SUBJECT: ISSUANCE OF AMENDMENT (TAC NO. M84564)

The Commission has issued the enclosed Amendment No. 123 to Facility Operating License No. DPR-19 for Dresden, Unit 2. The amendment is in response to your application dated September 14, 1992.

The amendment revises the pressure/temperature (P/T) limits in Section 3.6 of the Technical Specifications (TS) to correct a deficiency in the P/T limits currently in the TS identified by you.

AMENDMENT TO FACILITY OPERATING LICENSE

FIGURE 3.6.1.

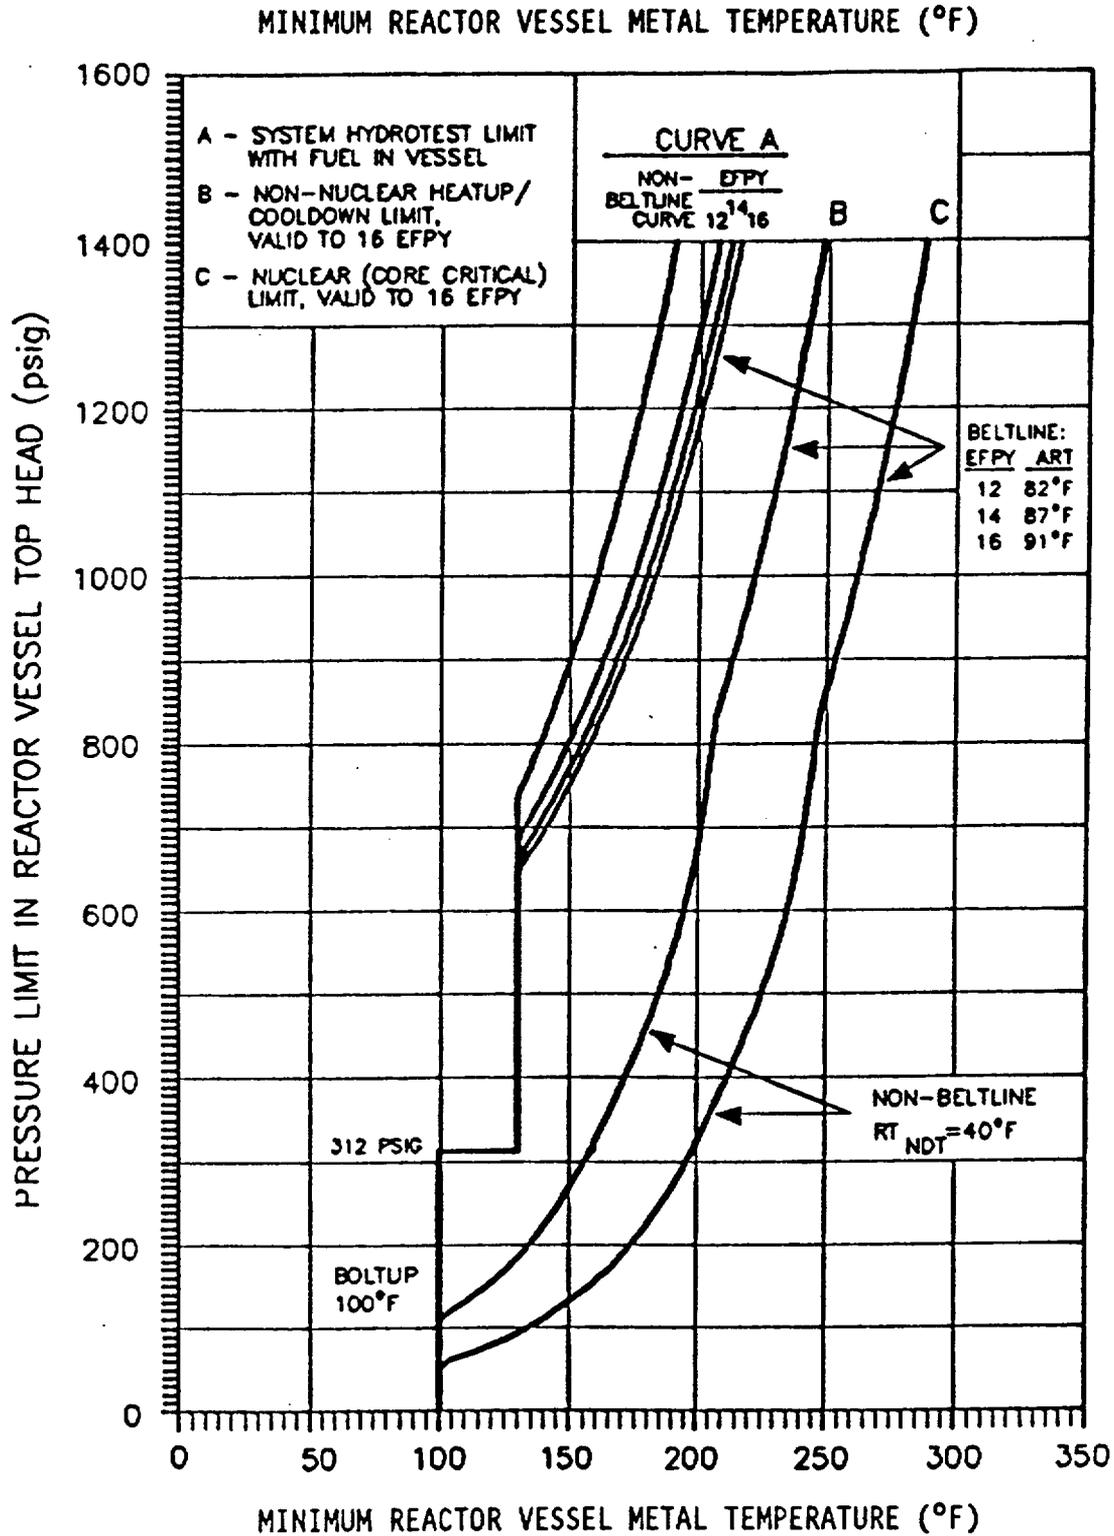
Revise the Appendix A Technical Specifications by removing the pages identified below and inserting the attached pages. The revised pages are identified by the captioned amendment number and contain marginal lines indicating the area of change.

As indicated in Curve A of Figure 3.6.1 for system hydrotesting, the minimum metal temperature of the reactor vessel shell is 100°F for reactor pressures less than 312 psig. This 100°F minimum boltup temperature is based on an RT<sub>NDT</sub> of 40°F for the electroslag weld immediately below the vessel flange and a 60°F conservatism required by the original ASME Code of construction.

At reactor pressures greater than 312 psig the minimum vessel metal temperature is established as 130°F. The 130°F minimum temperature is based on a closure flange region RT<sub>NDT</sub> of 40°F and a 90°F conservatism required by 10 CFR 50 Appendix G for pressure in excess of 20% of the preservice hydrostatic test pressure (1563 psig).

At approximately 650 psig the effects of pressurization are more limiting than the boltup stresses at the closure flange region, hence a family of non-linear curves intersect the 130°F vertical line. Belt-line as well as non-beltline curves have been provided to allow separate monitoring of the two regions. Beltline curves as a function of vessel exposure for 12, 14, and 16 effective full power years (EFPY) are presented to allow the use of the appropriate curve up to 16 EFPY of operation.

Curve B of Figure 3.6.1 applies during heatups with non-nuclear heat (e.g., recirculation pump heat) and during cooldowns when the reactor is not critical (e.g., following a scram). The curve provides the minimum reactor vessel metal temperatures based on the most limiting vessel stress.

As indicated by the vertical 100°F line, the boltup stresses at the closure flange region are most limiting for reactor pressures below approximately 110 psig. For reactor pressures greater than approximately 110 psig, pressurization and thermal stresses become more limiting than the boltup stresses, which is reflected by the non-linear portion of Curve B. The non-linear portion of the curve is dependent on non-beltline and beltline regions, with the beltline region temperature limits having been adjusted to account for vessel irradiation (up to a vessel exposure of 16 EFPY). The non-beltline region is limiting between approximately 110 psig and 830 psig. Above approximately 830 psig, the beltline region becomes limiting.

Curve C, the core critical operation curve shown in Figure 3.6.1, is generated in accordance with 10 CFR 50 Appendix G which requires core critical pressure-temperature limits to be 40°F above any Curve A or B limits. Since Curve B is more limiting, Curve C is Curve B plus 40°F.

The licensee selected properties among all beltline materials in Dresden and Quad Cities reactors that would give the highest ART. The licensee used (1) the chemical composition of longitudinal seam weld, PQ-1300, in Dresden Unit 3, (2) the initial nil ductility transition reference temperature ( $RT_{ndt}$ ) of the longitudinal weld in Dresden Unit 2 (Reference 1), and (3) the predicted neutron fluence of Dresden Unit 3 at 16 EFPY. The result of this conservative approach is that the limiting material, from which the proposed P/T limits were constructed, has 0.3% copper, 0.33% nickel, and an initial  $RT_{ndt}$  of 40 °F. The neutron fluence used was  $1.8E17$  n/cm<sup>2</sup> at 1/4T (T = reactor vessel beltline thickness). The licensee calculated a limiting ART of 91 °F at 1/4T which the staff confirmed to be correct using the RG 1.99 method.

The licensee's ART of 91 °F is more conservative than the staff's ART of 59.5 °F and is acceptable. Substituting the ART of 91 °F into equations in SRP 5.3.2, the staff verified that the proposed P/T limits for heatup, cooldown, and hydrotest meet paragraph IV.A.2 of Appendix G to 10 CFR Part 50.

and leak tests. Paragraph IV.A.3 of Appendix G states "an exception may be made for boiling water reactor vessels when water level is within the normal range for power operation and the pressure is less than 20 percent of the pre-service system hydrostatic test pressure. In this case the minimum permissible temperature is 60 °F (33 °C) above the reference temperature of the closure flange regions that are highly stressed by the bolt preload." Based on the flange reference temperature of 20 °F, the staff has determined that the proposed P/T limits satisfy paragraph IV.A.3 of Appendix G.

The staff concludes that the proposed P/T limits for heatup, cooldown, leak test, and criticality are valid through 16 EFY because the limits conform to paragraphs IV.A.2, IV.A.3, & IV.A.4 of Appendix G to 10 CFR Part 50. The proposed P/T limits also satisfy GL 88-11 because the licensee used the method in RG 1.99, Revision 2, to construct the limits. Hence, the proposed P/T limits may be incorporated into the Dresden, Unit 2, TS.
